**Clarification Package - Request For Proposals**

**STRUCTURED CABLING AND LOW-VOLTAGE DEVICE INSTALLATION**

Shoreline Family Health Care

**Additional Scope at Pharmacy Space**

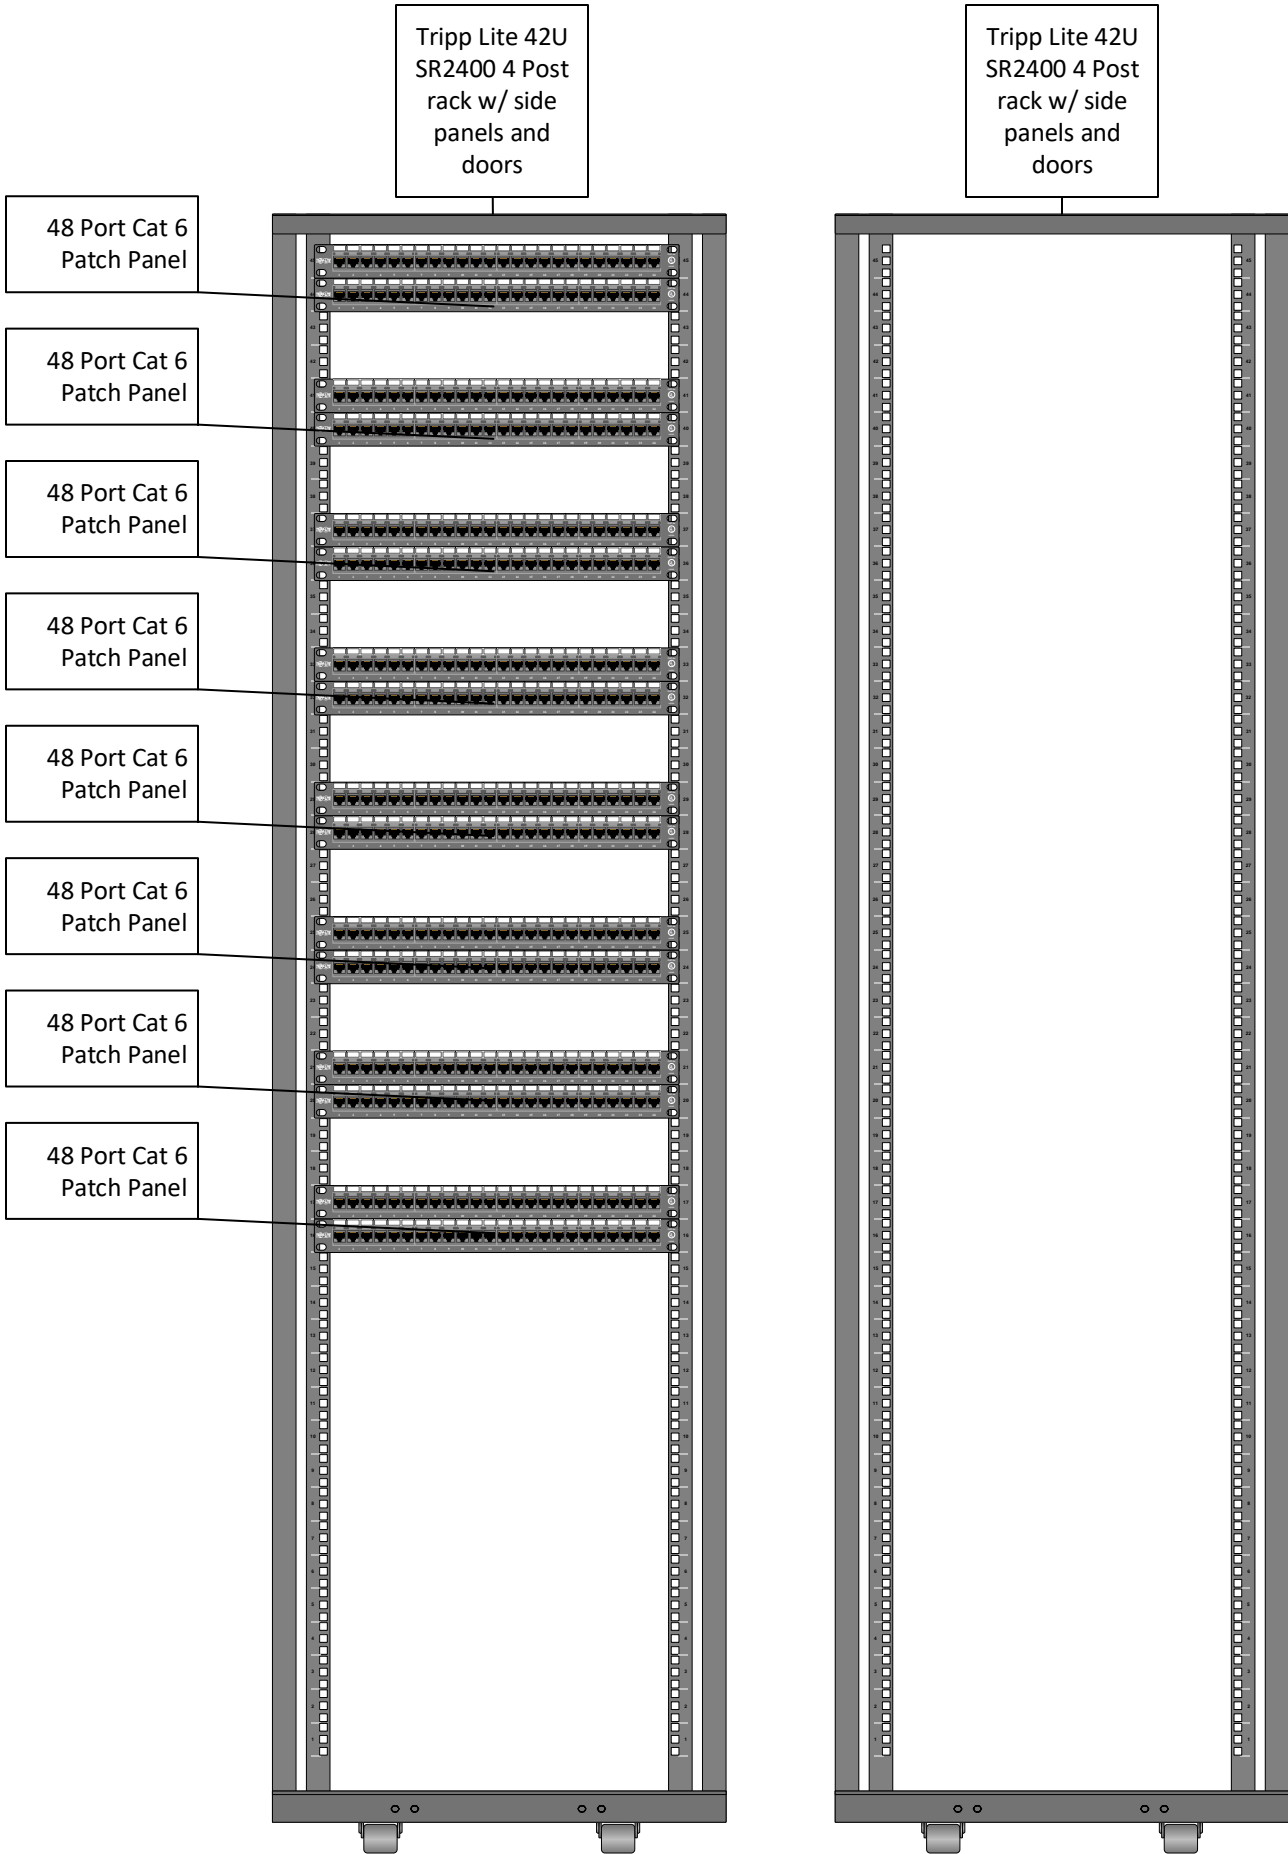
Additional requirements for cabling within the pharmacy space are attached to this clarifications package. Requirements include: 10 lines in adjacent wall to be terminated in millwork/work counter; 2 drops on sink wall as shown on the original location drawing; 7 lines to be run and coiled above ceiling for future camera installation; 20 additional lines, termination locations TBD; 1 WAP as shown on the original location drawing.

**DATA PLAN**

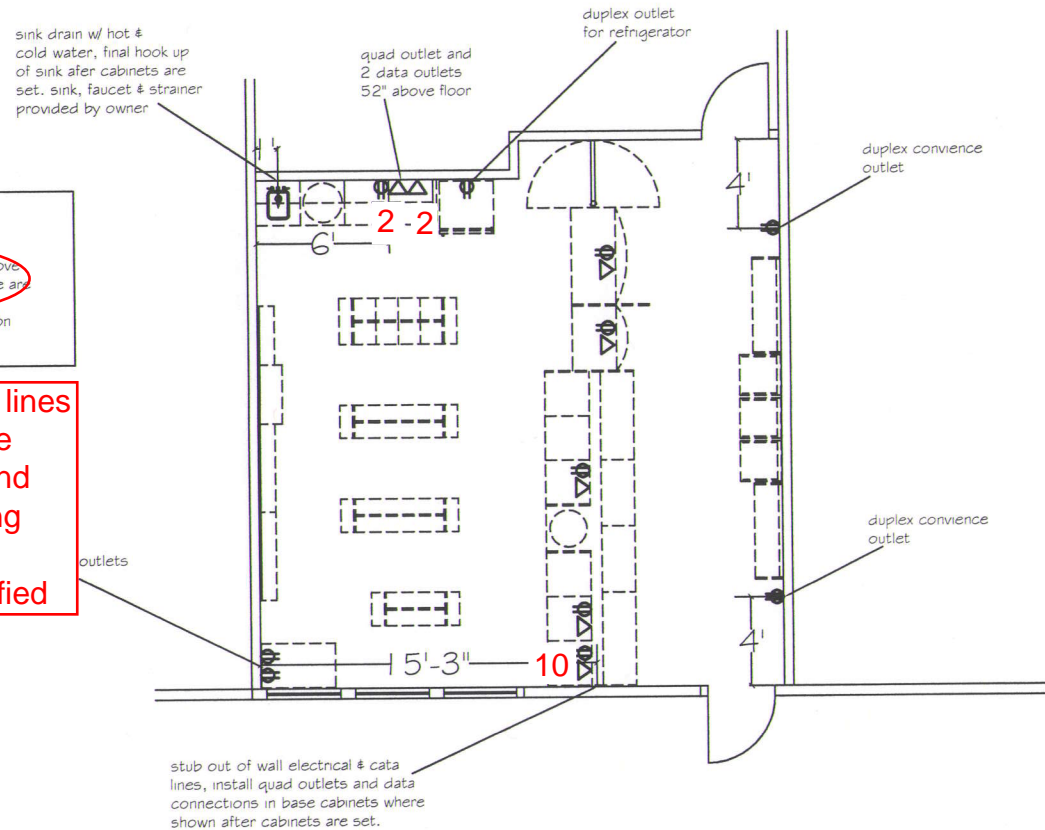
provide 7 additional data lines above ceiling for security cameras, these are in addition to those shown on the drawing. owner will provide location of cameras.

20 additional cable lines should be run to the Pharmacy space and left above the ceiling until termination locations are identified
